E-007 RS-485 / MODBUS RTU COMMUNICATION

Conv_Simple / CV-101 (garage conveyor) — Micro820 (master) ↔ GS10 (node 1) · Modbus RTU only

RS-485 / MODBUS RTU Conv_Simple / CV-101 (garage conveyor)	SHEET E-007
MIRA / FactoryLM recovers MIRA-WI-001 / Conv_Simple_CommsToVFD §2	REV A 2026-07-107 of 9

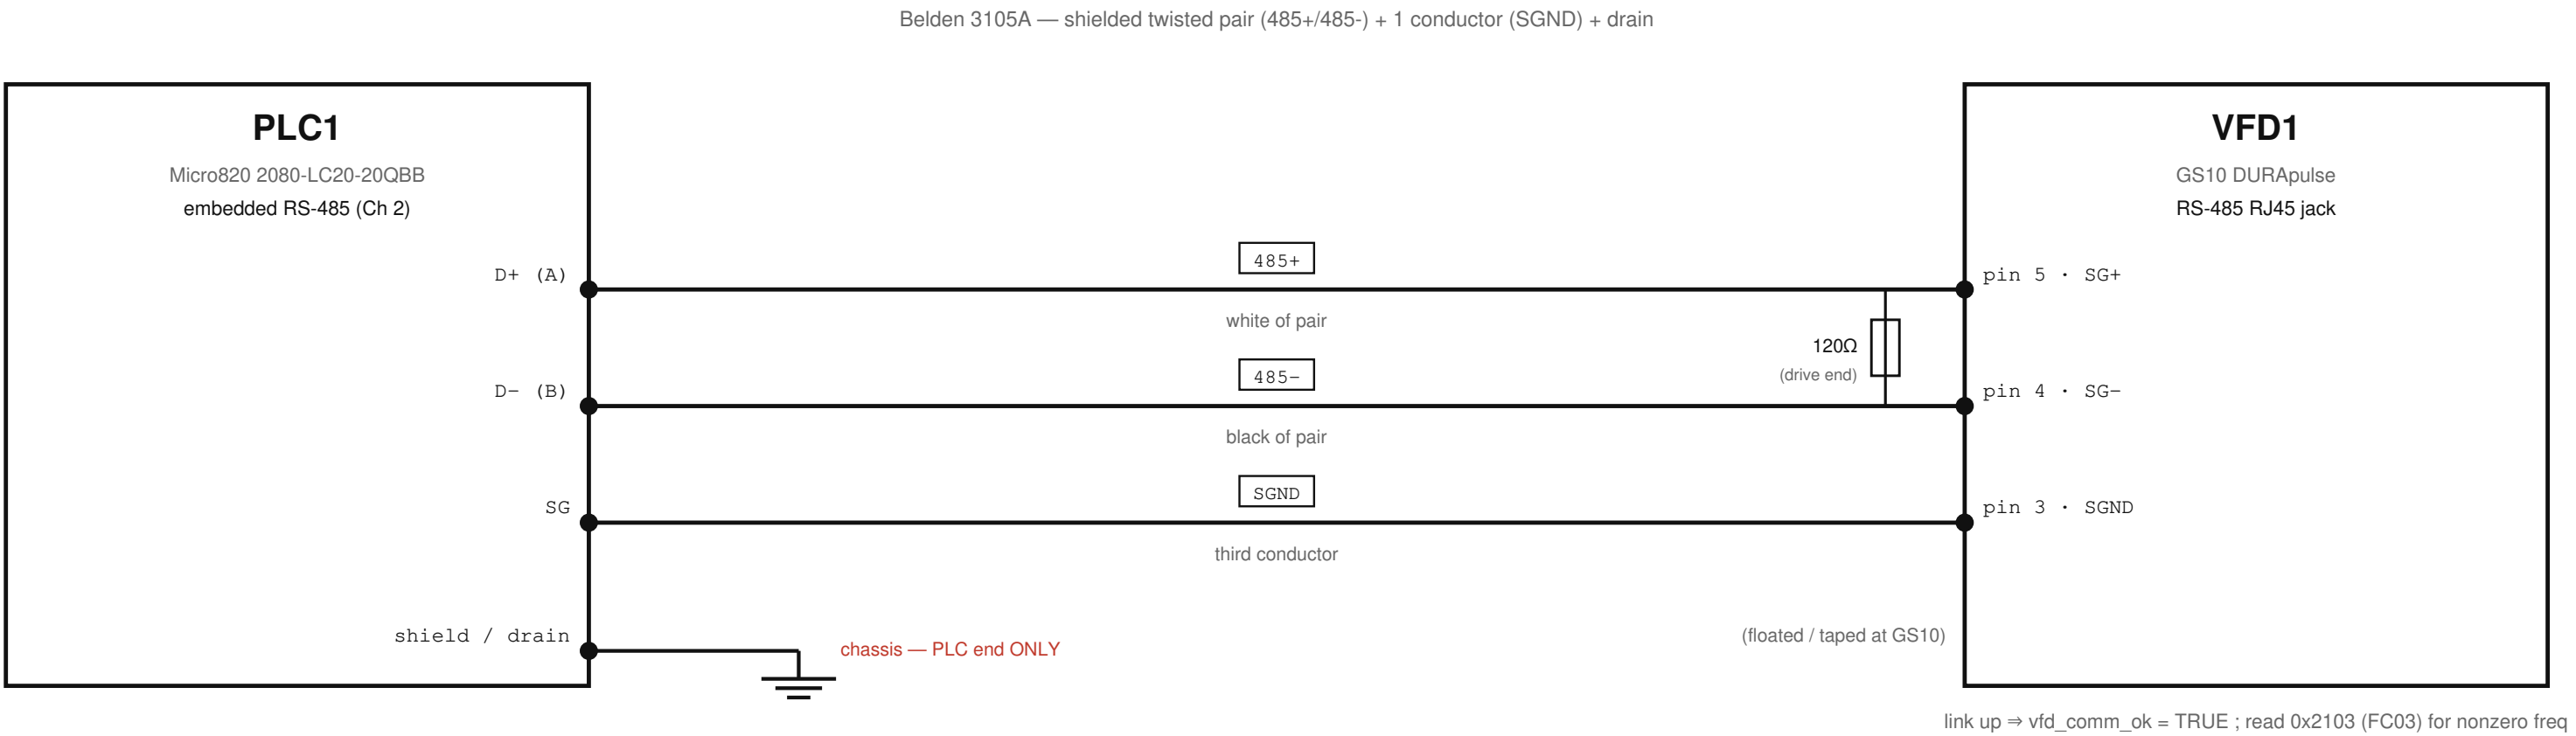
Older GS10_Integration_Guide.md said 8N2 (P09.04=13) - SUPERSEDED by bench-verified 8N1.

CORRECTED from May-16 draft: Channel 0 → 2 · SGND pin 1/8 → pin 3 · 8N2 → 8N1. Do not copy the old values.

CCW SERIAL PORT: Modbus RTU, Master · 9600 · 8N1 (P09.04 = 12) · Channel 2 · Node 1 (P09.00 = 1)
